Control sheet for Standard Engineering Details 0612, 0613, 0614, 0617 and 0626

12 August 2009:

Revisions to standard engineering details as follows:

**CONCRETE VEHICLE CROSSING
TRANSITIONS**

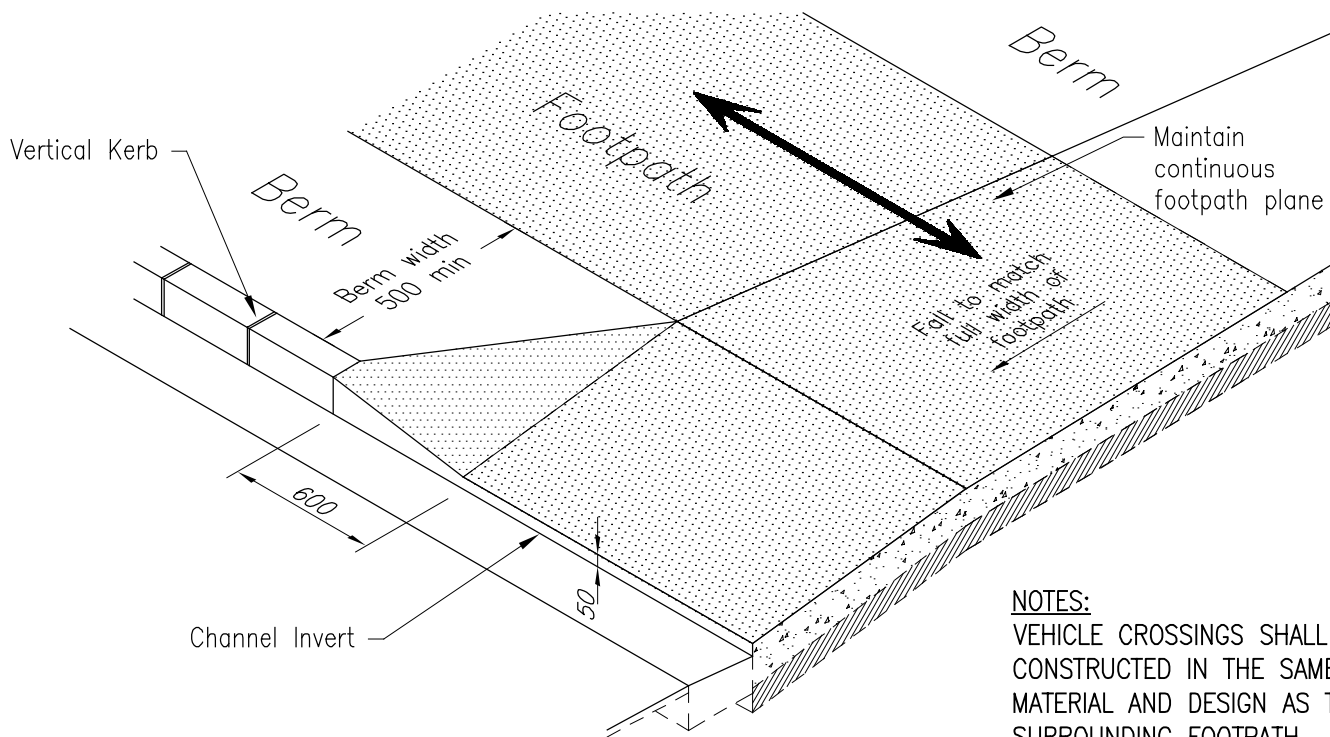
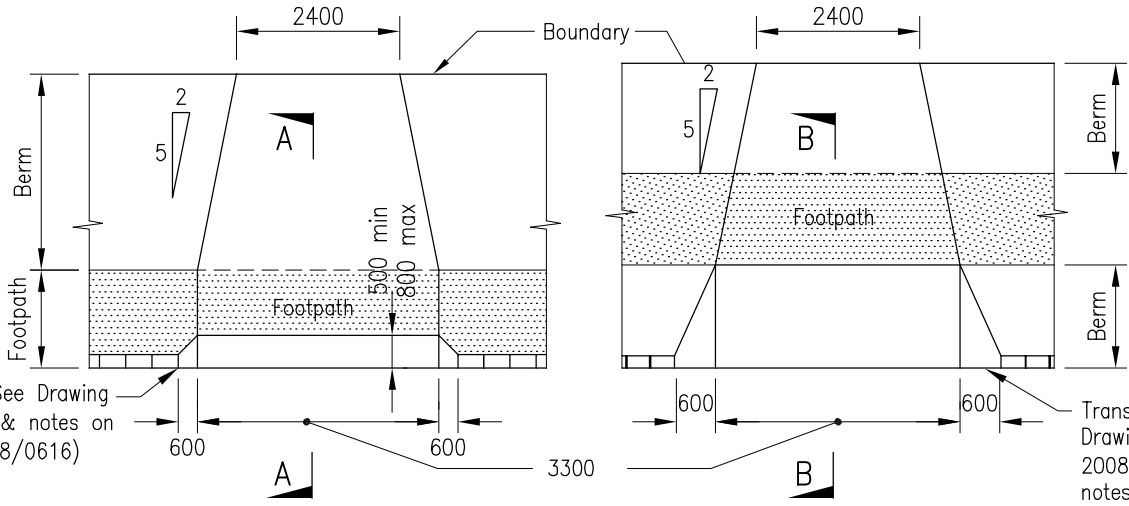
- Increased height of the 'lip' from 20mm to 50mm.
- Removal of the radial block.
- The taper of the splay at the entrance of the vehicle crossing has been standardised to 600mm on each side.
- For vehicle crossing next to the kerb - the ramp depth has been specified to be a minimum of 500mm and a maximum of 800mm to provide for a 1 meter wide continuous footpath plane for pedestrians. Fall to match the full width of the footpath.
- The width of the vehicle crossing at the boundary and at the kerb side has been corrected to reflect a single vehicle entrance i.e 6000 max width dimension has been removed.
